UNITED STATES PATENT AND TRADEMARK OFFICE

Office Action Summary

10/592,969

DETAILED ACTION

Leimkuehler Fig. 4

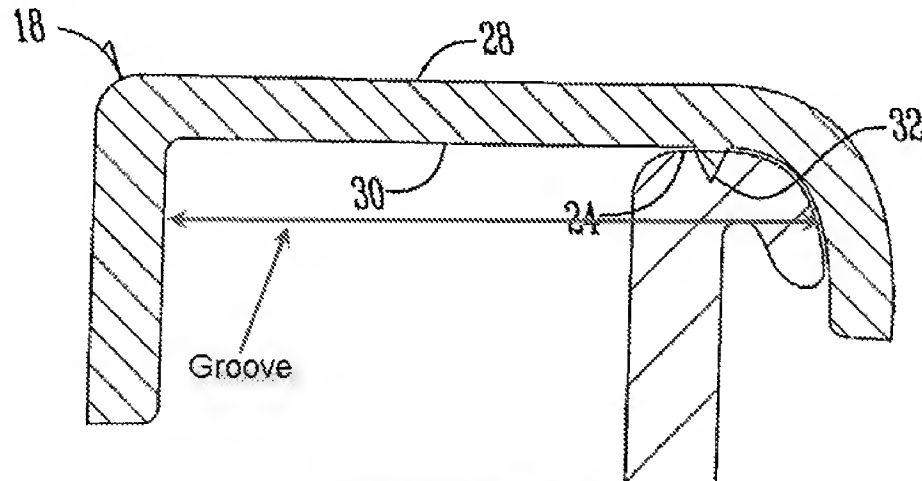
9. Regarding claim 20, Leimkuehler discloses a refrigerator comprising: an inner space (inside of 10) enclosed by a heat-insulating housing (walls of 10); at least one compartment (16) for accommodating articles to be cooled and being disposed within the inner space (Fig. 1) and having a curved edge (24); and a strip (18) disposed on a top of the curved edge (Figs. 2-4) and including a plastic core (§ 21) wherein the strip has a groove (see annotated Fig. 4) into which the edge of the compartment for accommodating articles to be cooled is inserted (Fig. 4).

12. Regarding claim 11, Leimkuehler, as modified, teaches a refrigerator wherein the strip has a groove (see annotated Fig. 4) into which the edge of the compartment for accommodating articles to be cooled is inserted (Fig. 4).
